STATE OF RHODE ISLAND
RIDOT Addendum Notification

RFP #7670815 – DESIGN BUILD SERVICES FOR EAST BAY BIKE PATH BRIDGE REPLACEMENT
(REQUEST FOR PROPOSALS)
ADDENDUM #10
SUBMISSION DUE DATE: April 20, 2022 at 11:30 am

BEST VALUE DESIGN-BUILD PROCUREMENT FOR
EAST BAY BIKE PATH
REQUEST FOR PROPOSALS

ADDENDUM #10

BARRINGTON BRIDGE
EAST POLE (OTHERS SIMILAR)

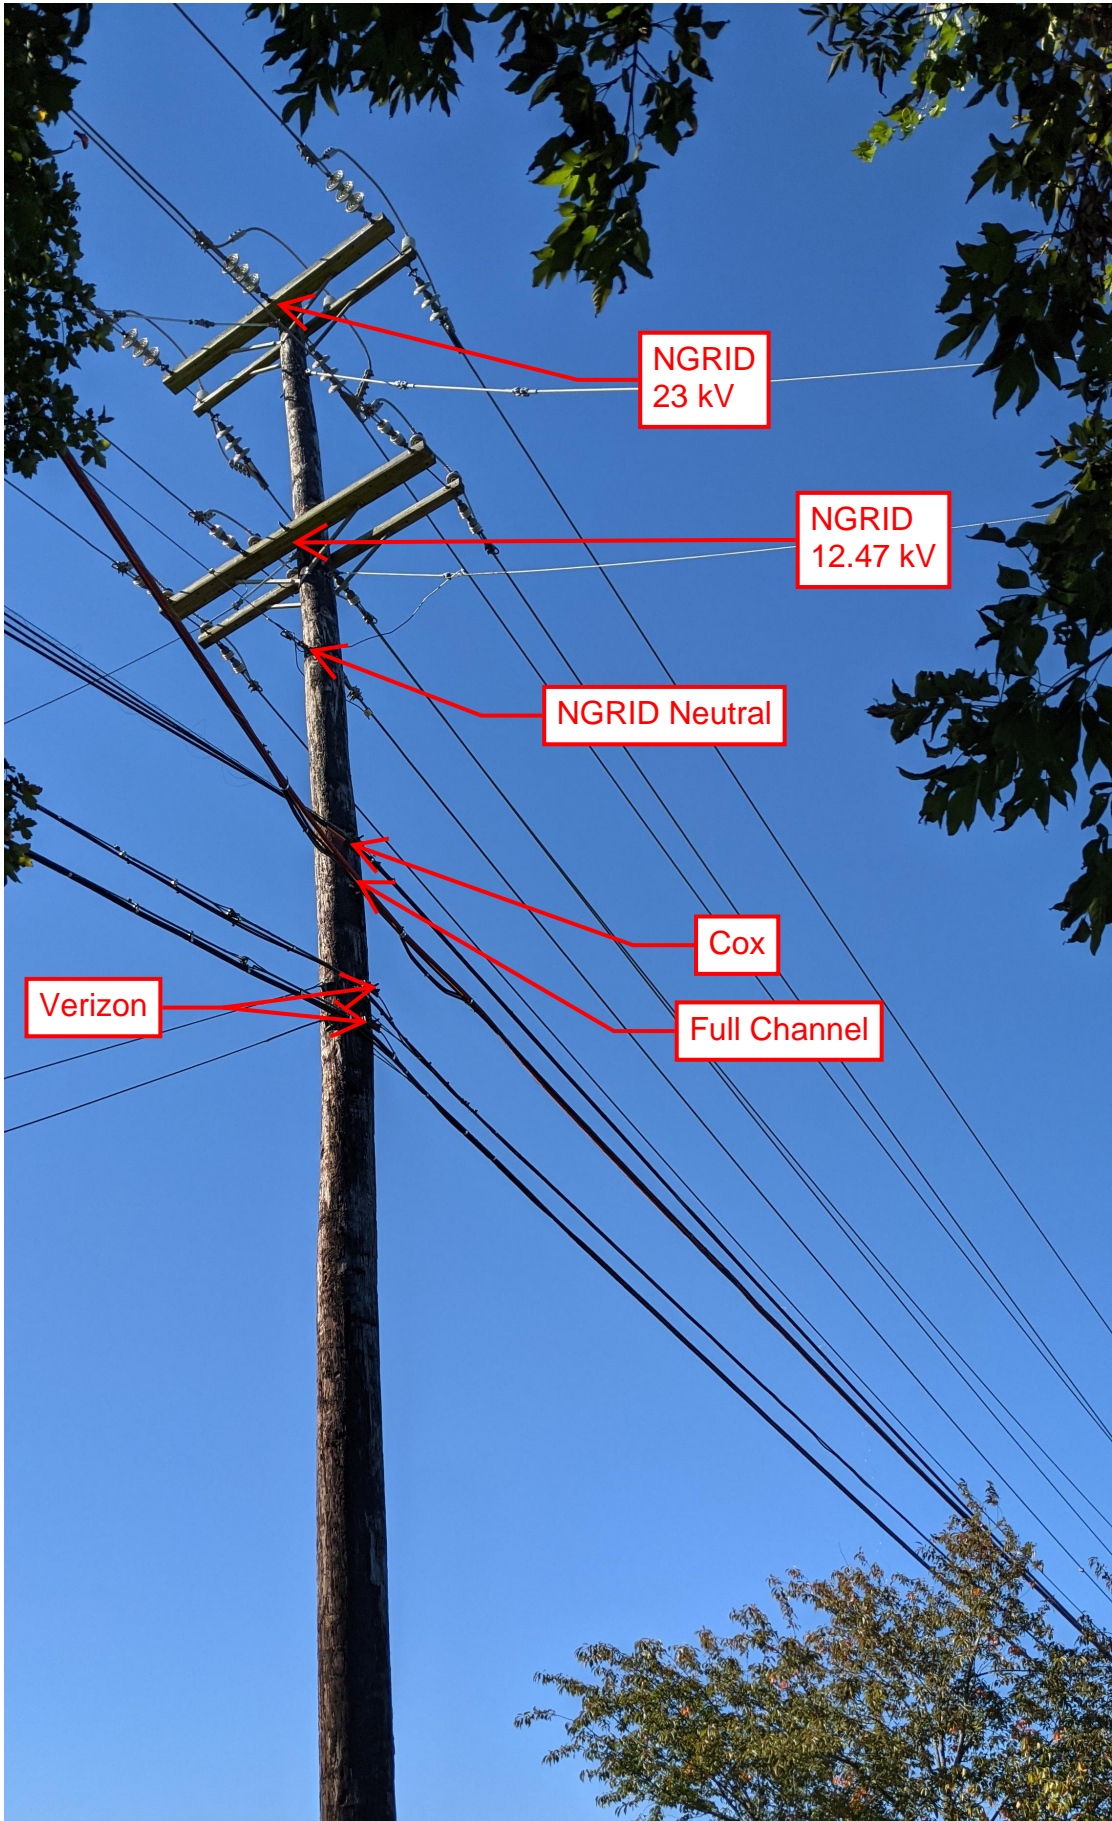
responsible for selecting the green infrastructure/stormwater treatment units to meet those goals along with achieving RIDEM/CRMC permit requirements.	
Date Asked: 04/05/2022	Date Answered: 04/07/2022
Poster: Timothy McLaughlin	Company: SPS New England, Inc.
<p>Question: National Grid states that they have been directed not to provide information to the contractors. Can RIDOT please provide information identifying all existing services and disposition of wires occupying utility poles, with locations, circuits and voltages from all service providers on the site?</p>	
<p>Answer: NGRID has a 23 kV (highest) line, a 12.47 kV line, and a neutral line through the project area. The other utilities (Cox, Full Channel, and Verizon) have said they occupy low voltage facilities in the area. A graphic has been added in Addendum 9 identifying the lines on the poles.</p>	
Date Asked: 04/05/2022	Date Answered: 04/07/2022
